DESIGN ADVISORY BOARD

DESIGN ADVISORY BOARD Tuesday November 9, 2021 3:00 PM

To: The Design Advisory Board
From: Mary O'Neil, AICP, Principal Planner
RE: ZP21-509 72-76 Elmwood Avenue
Date: September 28, 2021

To: The Design Advisory Board
From: Ryan Morrison, Associate Planner
RE: ZP-21-732, 278 Main Street
Date: November 9, 2021

A-400

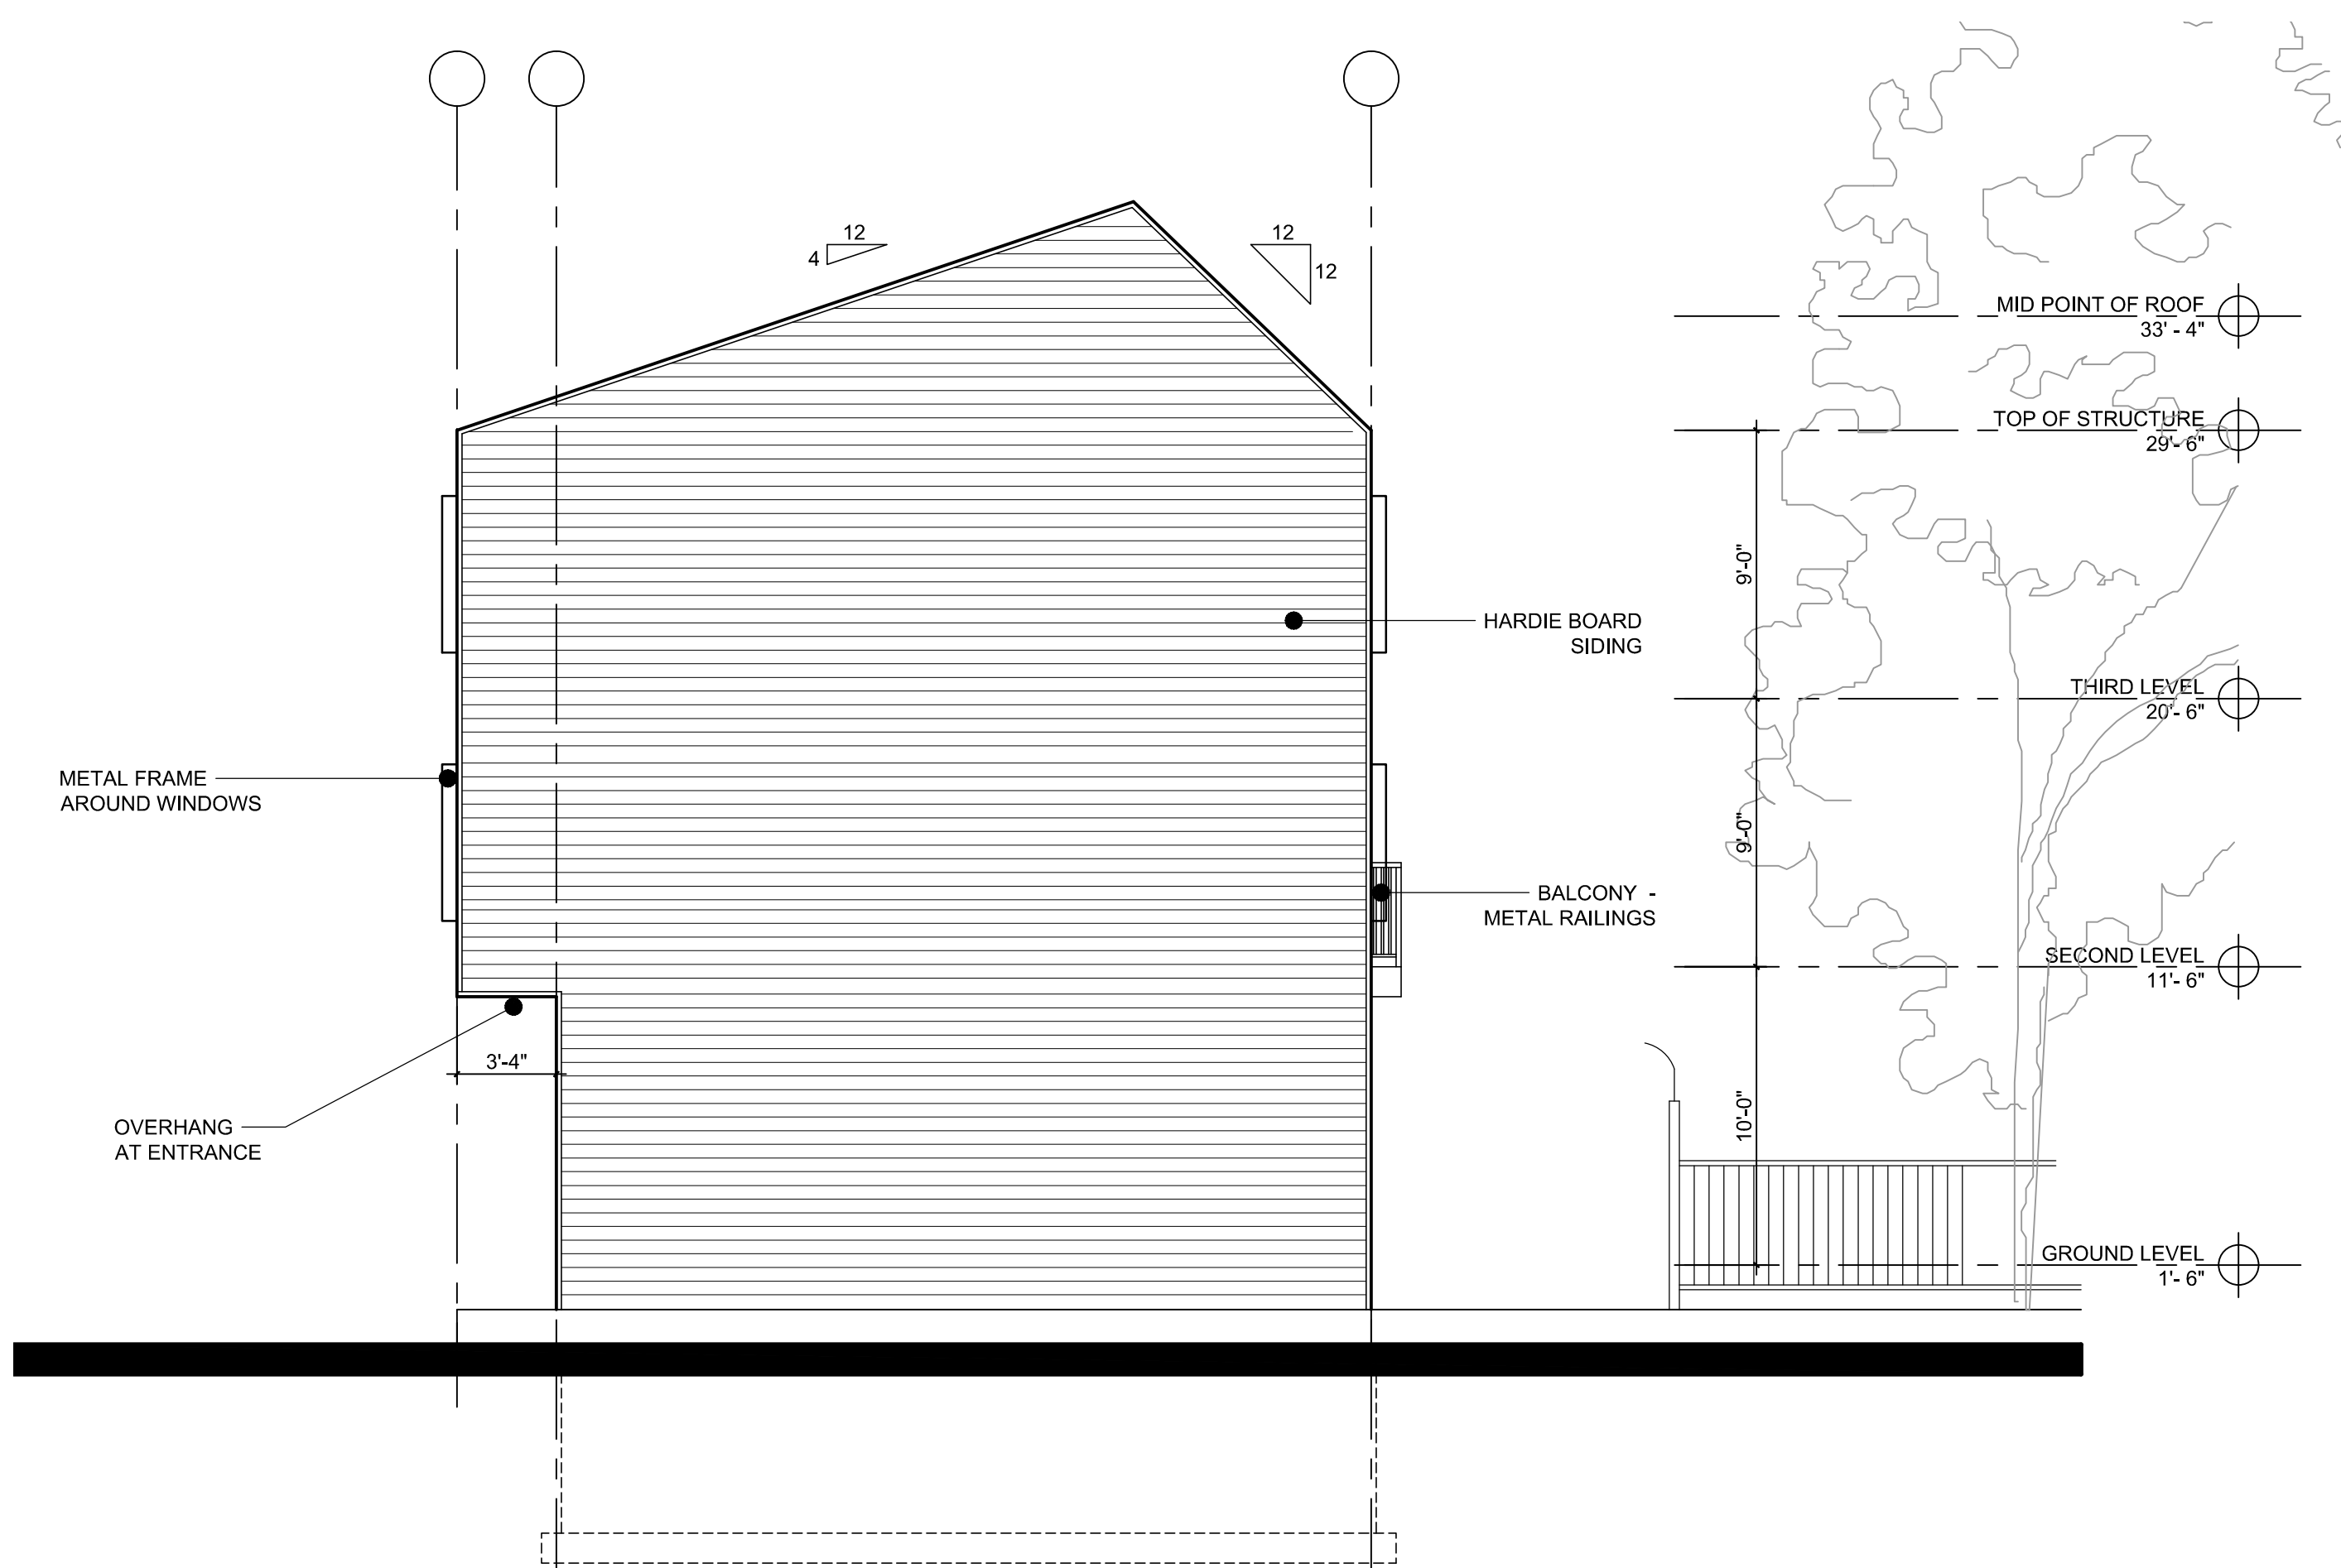
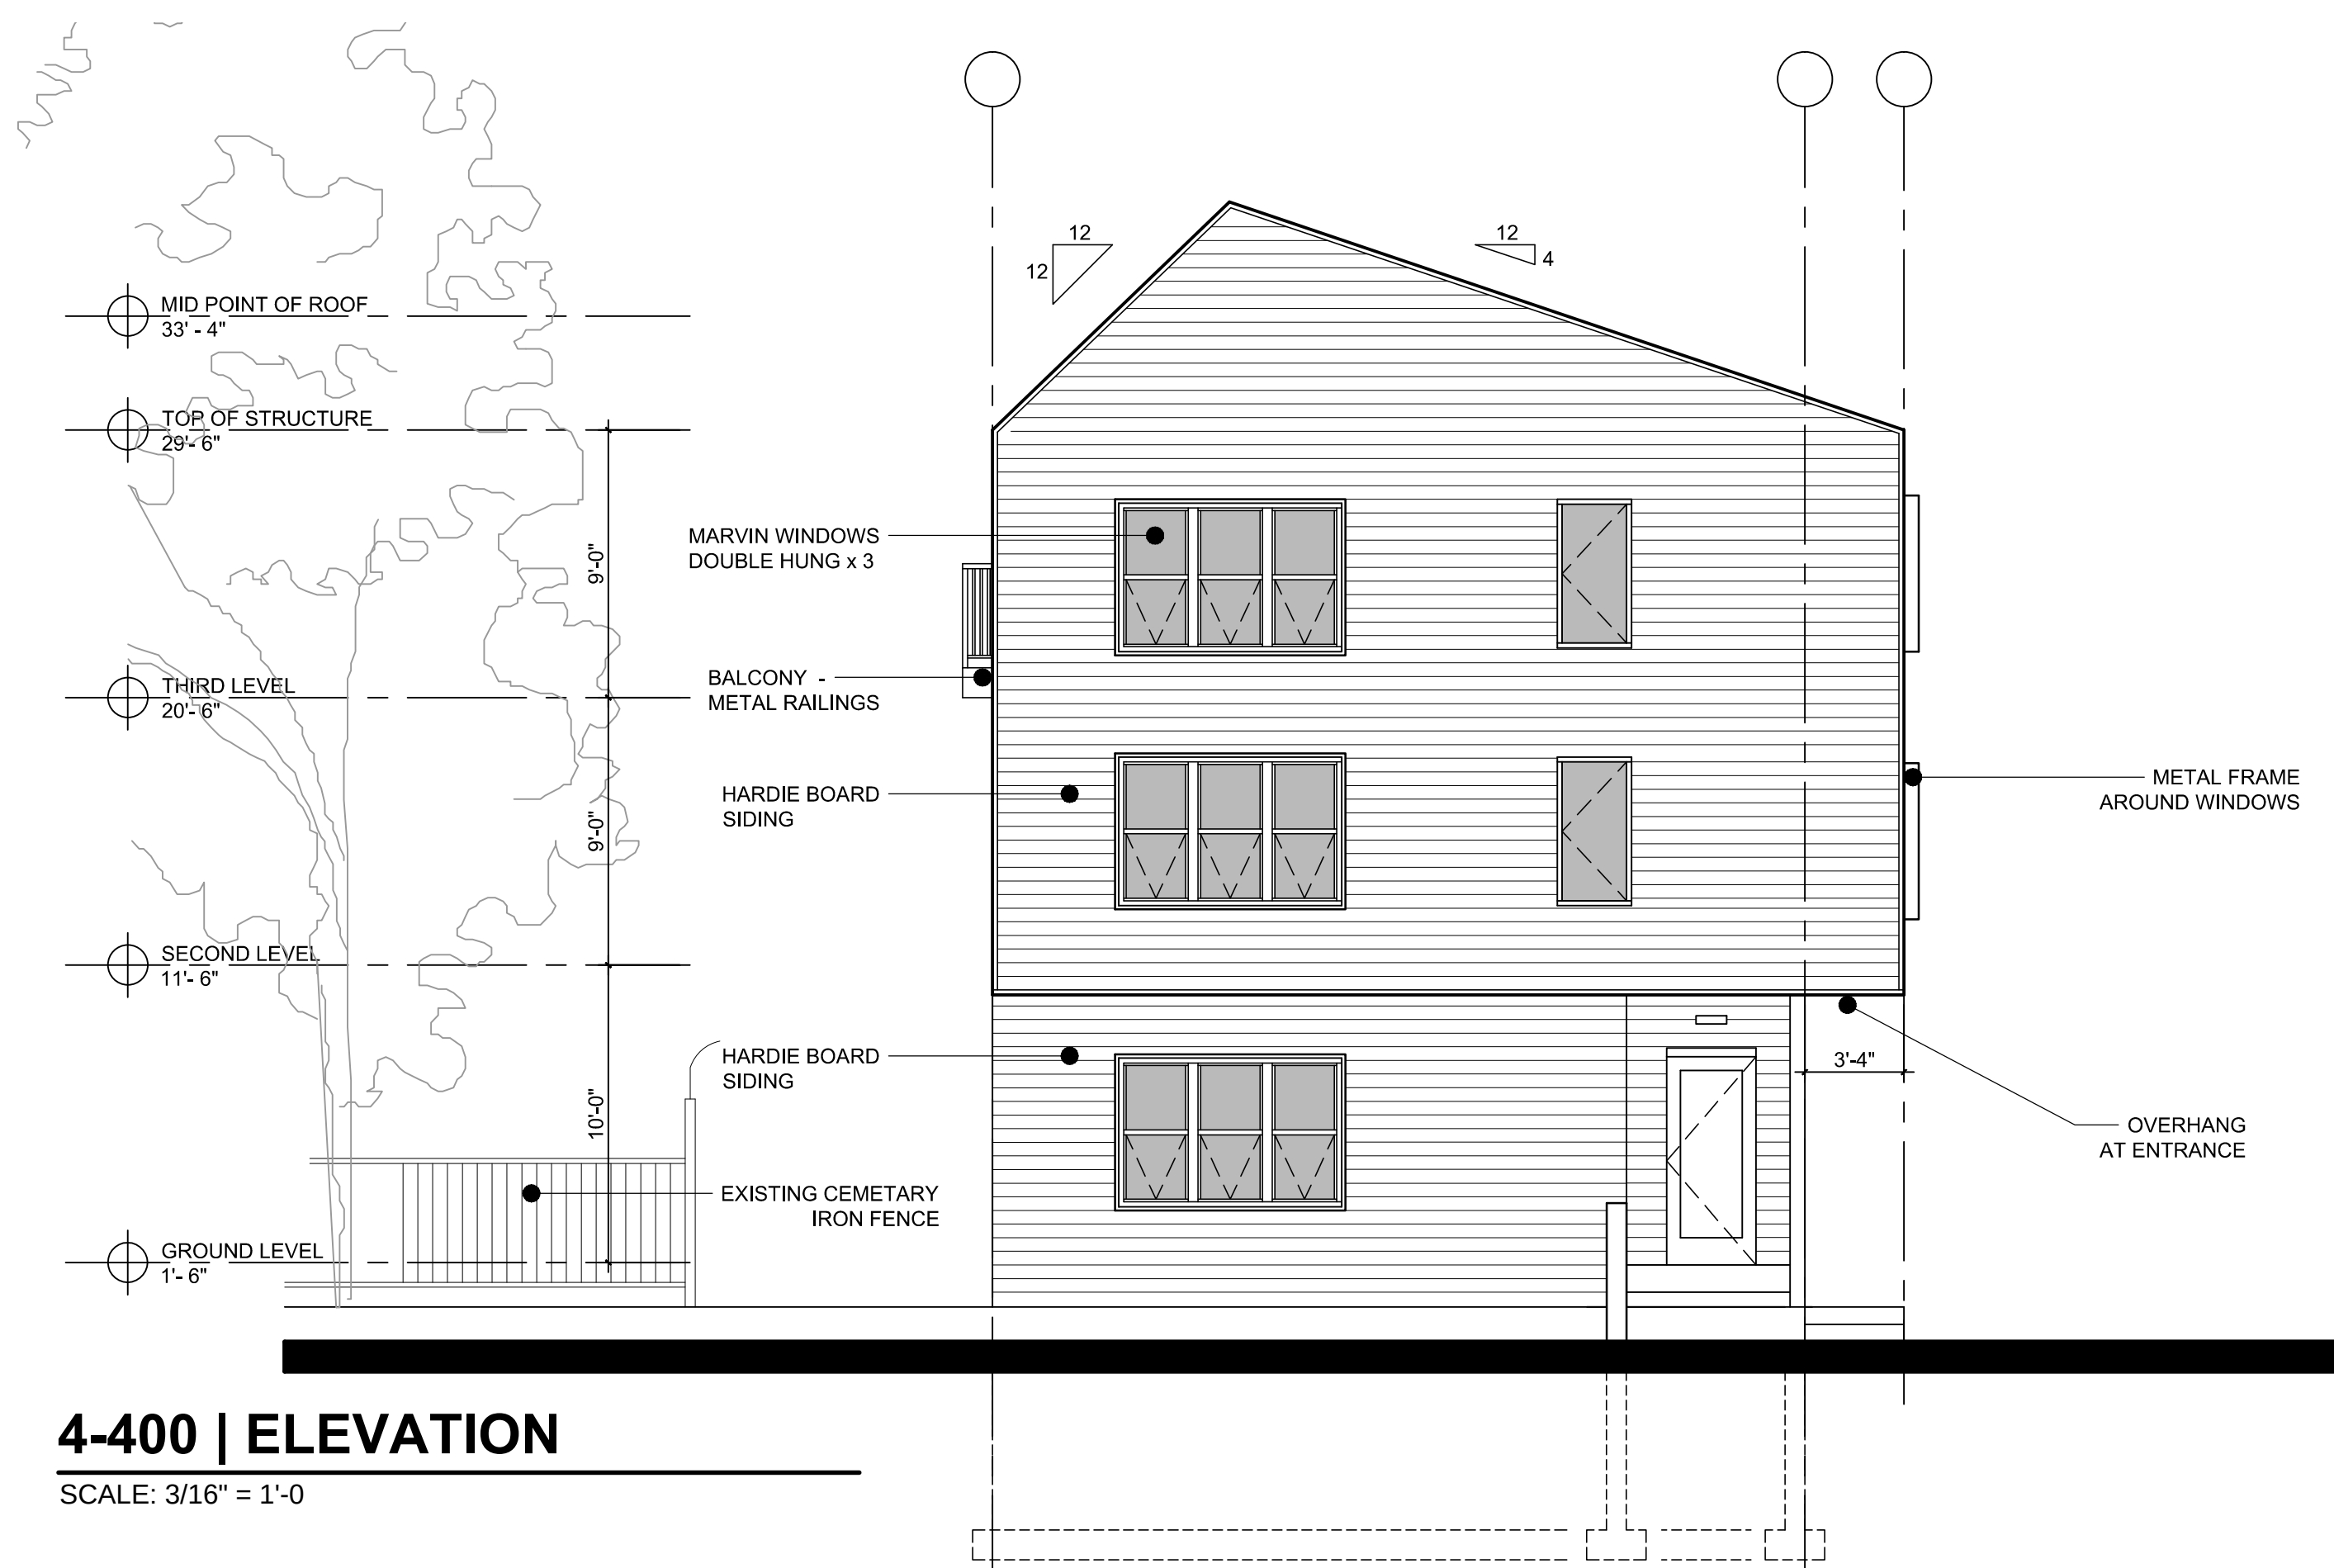
The proposed building has a modified cat-slide roof with dual pitch and zero eave extrusion. In style it reads as a modern infill.

As designed, the building lacks typical façade articulation such as bays, horizontal and vertical façade articulation, porches, patios, articulated bases, step-backs or other street level details. Windows are stacked, however, providing a measure of arrangement. The plan is modernistic with a simplified form and little detailing. The only interest provided is the angular and asymmetrical roof line.

Plans include fiber cement siding, with metal frame surrounds on windows and an asphalt shingle roof. All are considered acceptable for new construction.

- Any intended mechanical equipment (HVAC, Condensing Units, mini-splits, etc) shall be illustrated on the site plan/building elevations as appropriate. No mechanical equipment shall be allowed on the primary (westerly) elevation. Screening may be required elsewhere.
